Jicarilla H #109

Plug to Abandon Procedure:

Attachment to notice of Intention to Abandon:

CONDITIONS OF APPROVAL

Jicarilla H #109

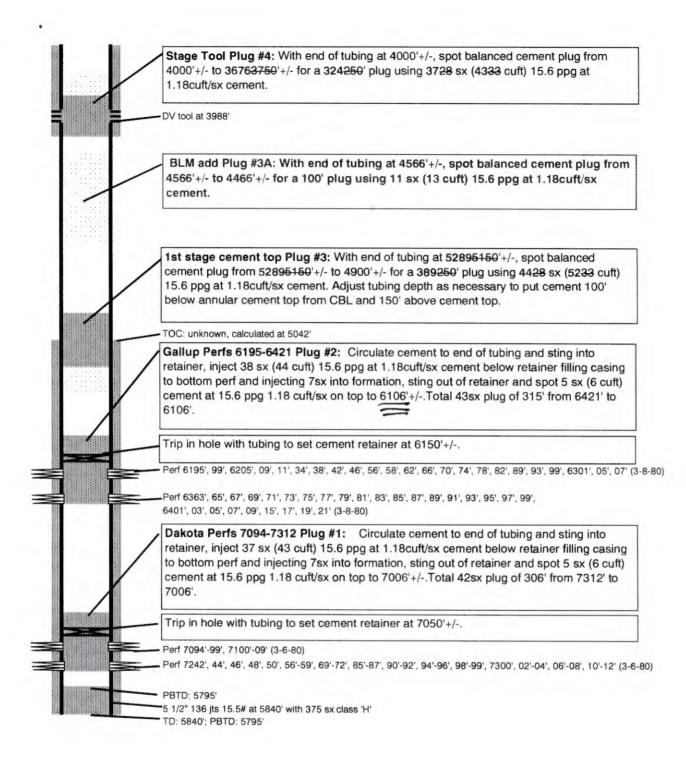
- 3. The following modifications to your plugging program are to be made:
 - a) Set Plug #3 (5289-4900) ft. to cover the Mancos shale tops. BLM picks top of Mancos at 5239 ft.
 - b) Add Plug to cover Cliff house top set plug (4566-4466) ft. BLM picks top of Cliff House at 4516 ft.
 - c) Set Plug #4 (4000-3676) ft. to cover the Chacra top. BLM picks top of Chacra at 3726 ft.
 - Add Plug to cover Pictured Cliffs top set plug (2930-2830) ft. BLM picks top of Pictured Cliffs at 2880 ft.
 - e) Add Plug to cover Fruitland top set plug (2760-2660) ft. BLM picks to of Fruitland at 2710 ft.
 - f) Add plug to cover Kirtland and the entire Ojo Alamo fresh water aquifer set plug (2602-2316) ft. BLM picks top of Kirtland at 2552 ft and Ojo Alamo at 2366 ft.
 - g) Add plug to cover Nacimiento top set plug (1116-1016) ft. BLM picks top of Nacimiento at 1066 ft.

You are also required to place cement excesses per 4.2 and 4.4 of the attached General Requirements.

Elevation: 6774' GR	Location:	Surface: 750' FNL, 210 Sec 5, T24N, R4W, Rid
	Proposed sketch after adding BLM COA's.		County, New Mexico
		API #:	30-039-22112
	Surface Plug #6: Squeeze through perforations at 300' with 90sx (1 from surface and circulating through 5 1/2"x 8 5/8" annulus leaving 5 cement and cement circulated to surface through perforations and 5 1	1/2" casing	full of
	 8 5/8" 24# K-55 STC at 298' with 300 sx class 'B', surface 		
l Per-	Perforate squeeze holes at 300'.		
	BLM add Plug #5A: With end of tubing at 1116'+/-, spot balanced 1116'+/- to 1016'+/- for a 100' plug using 11 sx (13 cuft) 15.6 ppg a cement.		
	2nd stage cement top Plug #5: With end of tubing at 2270'+/-, spot plug from 2270'+/- to 2020'+/- for a 250' plug using 28 sx (33 cuft) 15. cement. Adjust tubing depth as necessary to put cement 100' below a from CBL and 150' above cement top.	6 ppg at 1.	18cuft/sx
1-	TOC: unknown, calculated at 2170']

-	BLM add Plug #4C: With end of tubing at 2602'+/-, spot balance 2602'+/- to 2316'+/- for a 286' plug using 32 sx (38 cuft) 15.6 ppg cement.		
	BLM add Plug #4B: With end of tubing at 2760'+/-, spot balance 2760'+/- to 2660'+/- for a 100' plug using 11 sx (13 cuft) 15.6 ppg cement.
